RANDOLPH BUILDING
BERNALILLO COUNTY
ALBUQUERQUE, NEW MEXICO

HYDROLOGY SECTION

DRB SITE PLAN
FOR BUILDING PERMIT

DRAINAGE CERTIFICATION

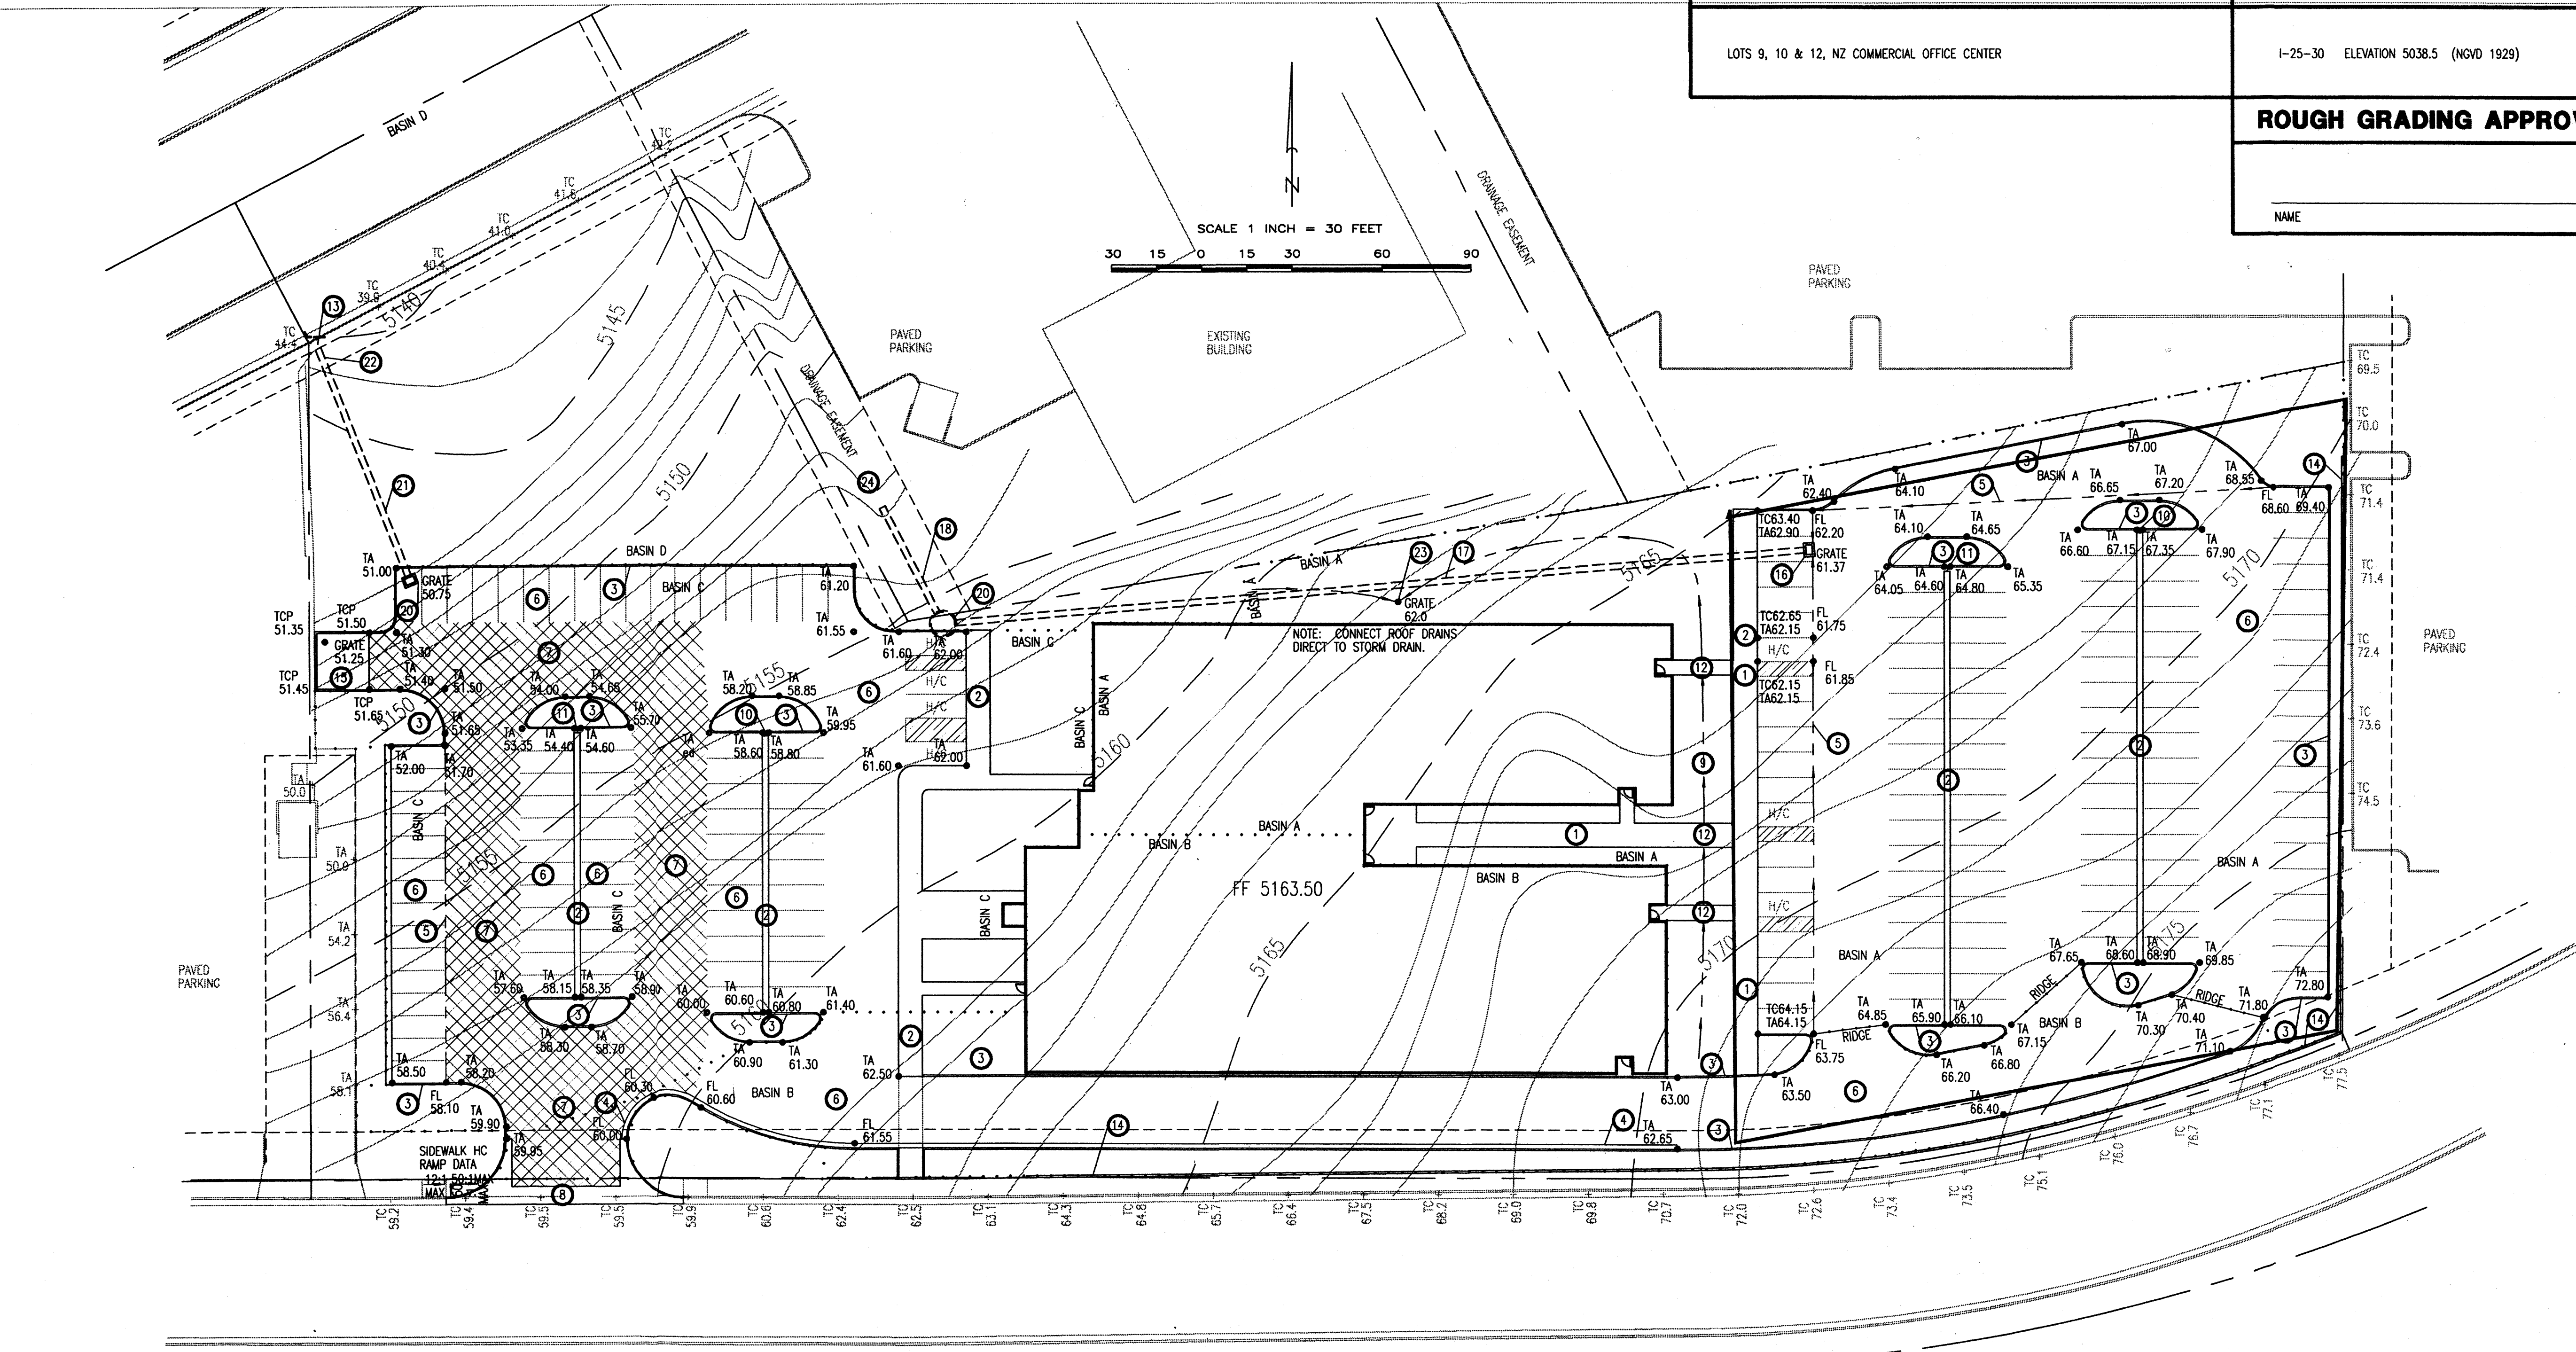
NOTE:
HAND LETTERED ELEV'S
ARE AS-BUILT 06/10/07

16. TYPE 'SINGLE D' CATCH BASIN PER COA STD. DET. 2206. GRATE 61.37, INVERT 58.37
17. 18" HDPE STORM DRAIN AT APPROX. 1.42%.
18. 18" HDPE STORM DRAIN AT APPROX. 4.1% ADJUST GRADE TO MATCH EXISTING ELEVATION AT OUTLET.
19. 4' DIAM. TYPE 'E' MANHOLE PER COA STD. DET. 2102. INV. 54.5, 21M C24
20. TYPE 'SINGLE D' CATCH BASIN PER COA STD. DET. 2206. GRATE 50.75, INVERT 48.25
21. 15" HDPE STORM DRAIN AT APPROX. 9.9%
22. CONCRETE TRANSITION. SEE DETAIL SHEET C2.
23. 64 SQ. IN. AREA DRAIN WITH CONCRETE COLLAR AND 3" PVC OUTLET PIPE TO 17.
24. TYPE 'L' RIPRAP OUTLET. SEE DETAIL SHEET C2, OPTION 1 ONLY.

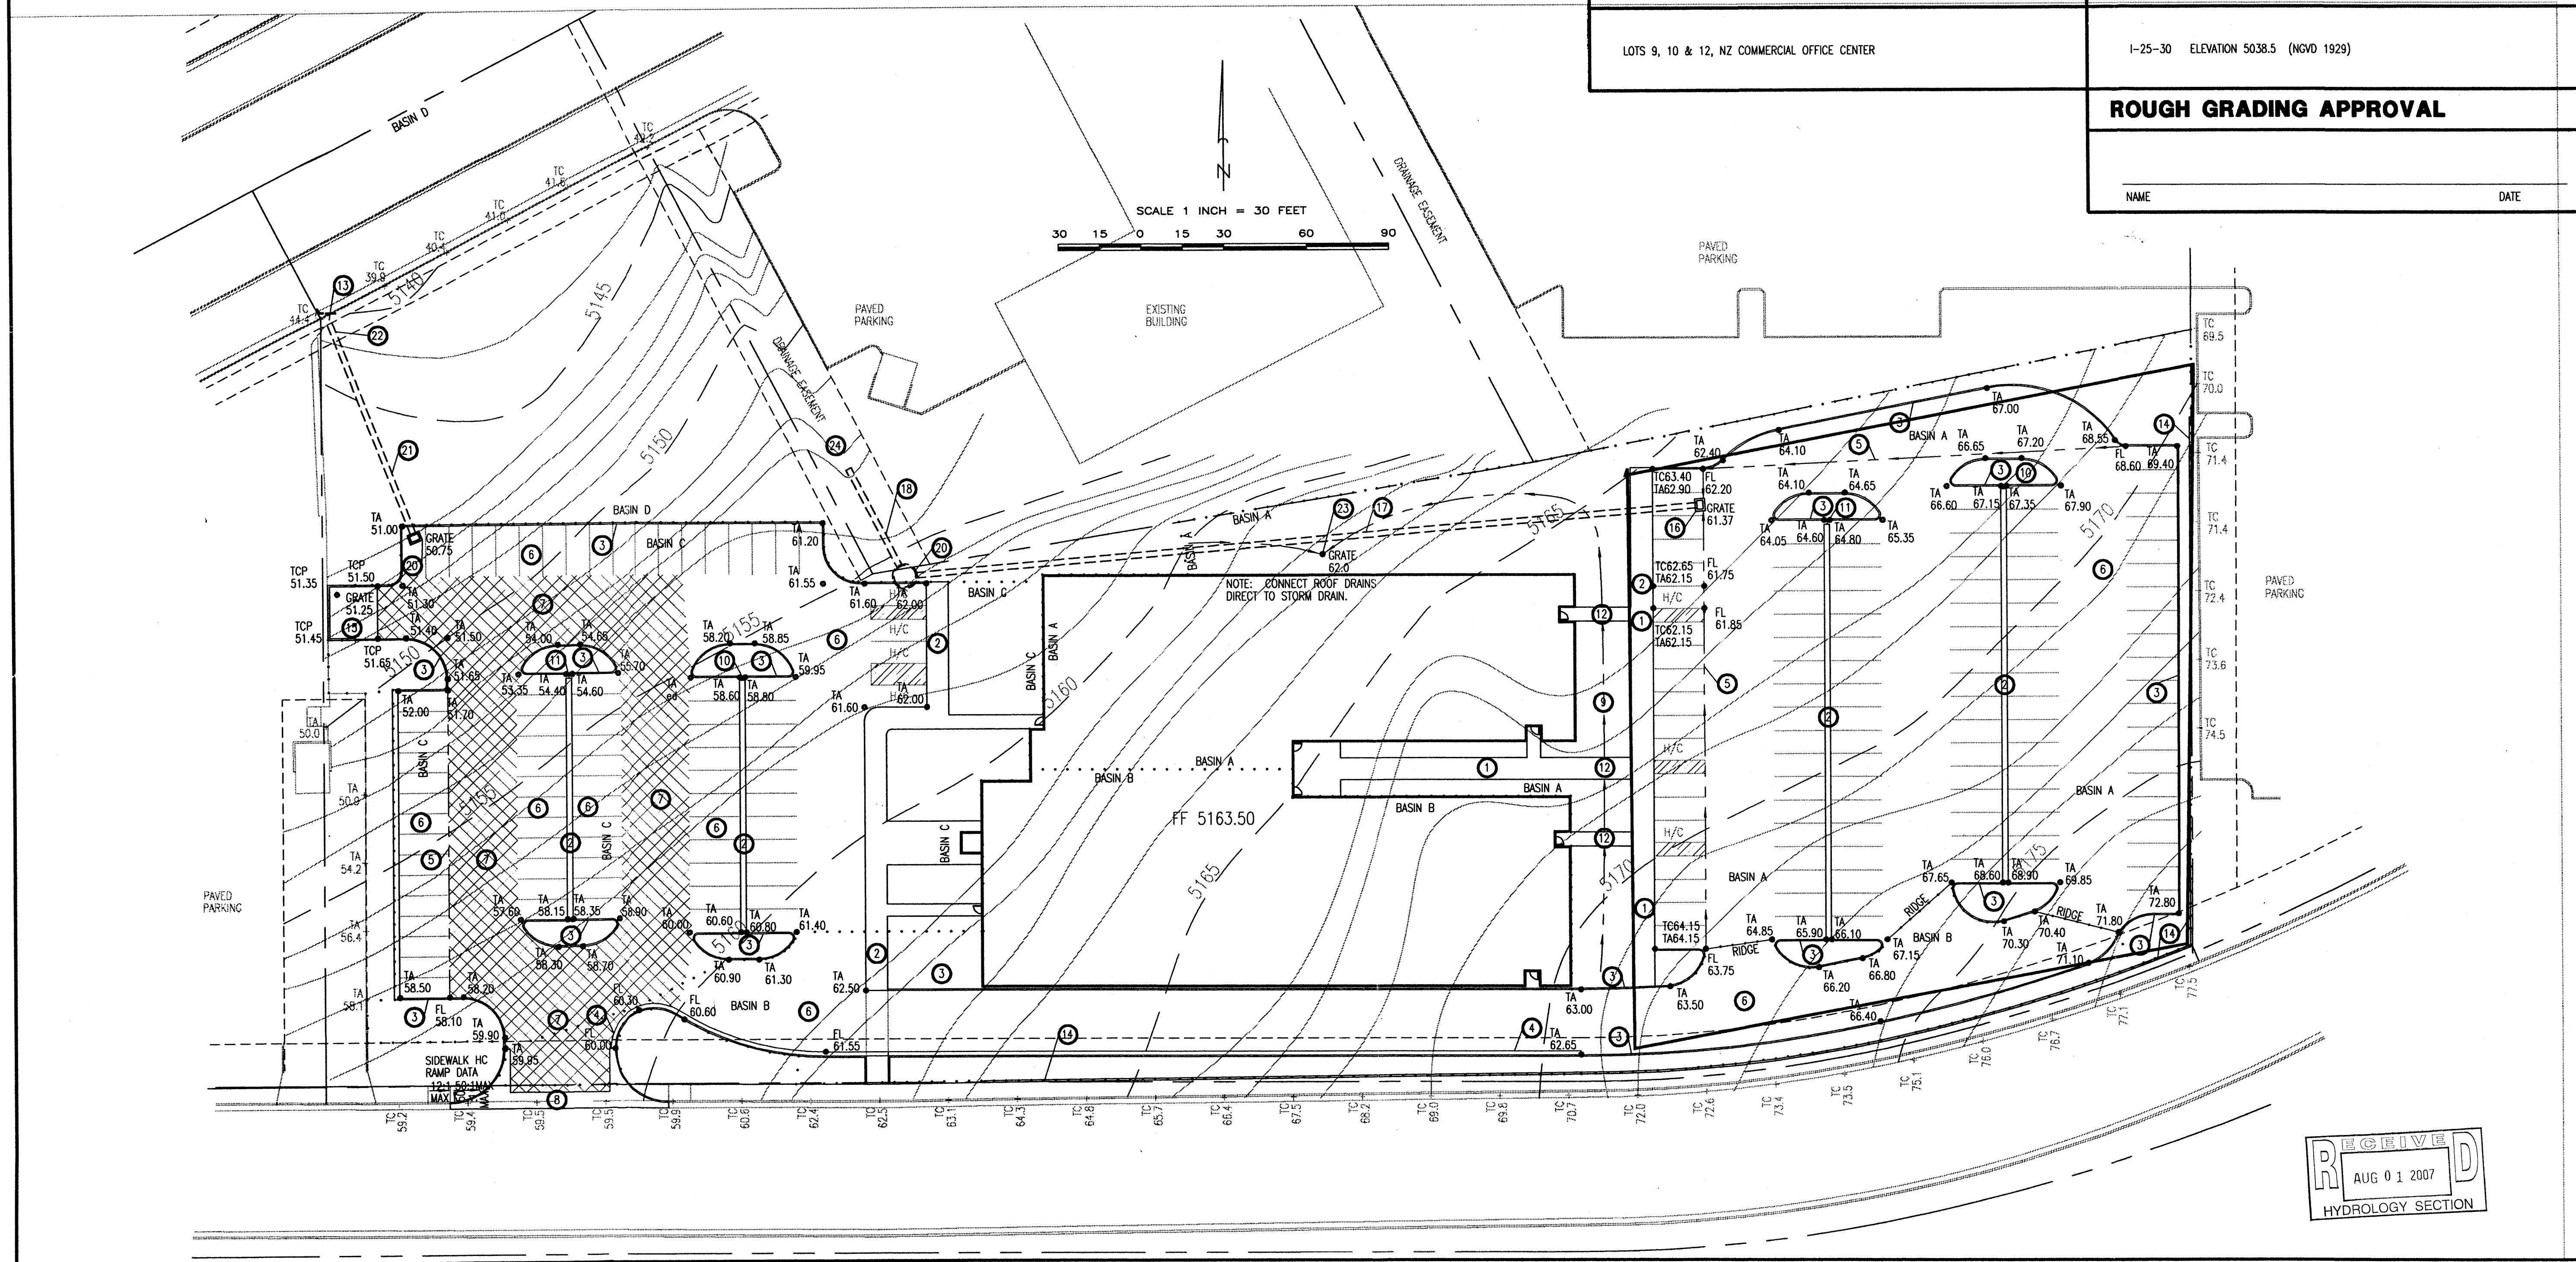
NOTE:
HAND LETTERED ELEV'S
ARE AS-BUILT 05/10/07

16. TYPE 'S' SINGLE D' CATCH BASIN PER COA STD. DET. 2206. GRATE 61.37, INVERT 58.37
17. 18" HDPE STORM DRAIN AT APPROX. 1.46%.
18. 18" HDPE STORM DRAIN AT APPROX 4.1% ADJUST GRADE TO MATCH EXISTING ELEVATION AT OUTLET.
19. 4' DIAM. TYPE 'E' MANHOLE PER COA STD. DET. 2102. INV. 54.5, DIA 62.4
20. TYPE 'S' SINGLE D' CATCH BASIN PER COA STD. DET. 2206. GRATE 50.75, INVERT 48.25
21. 15" HDPE STORM DRAIN AT APPROX 9.9%
22. CONCRETE TRANSITION. SEE DETAIL SHEET C2.
23. 64 SQ. IN. AREA DRAIN WITH CONCRETE COLLAR AND 3" PVC OUTLET PIPE TO 17.
24. TYPE 'L' RIPRAP OUTLET. SEE DETAIL SHEET C2, OPTION 1 ONLY.
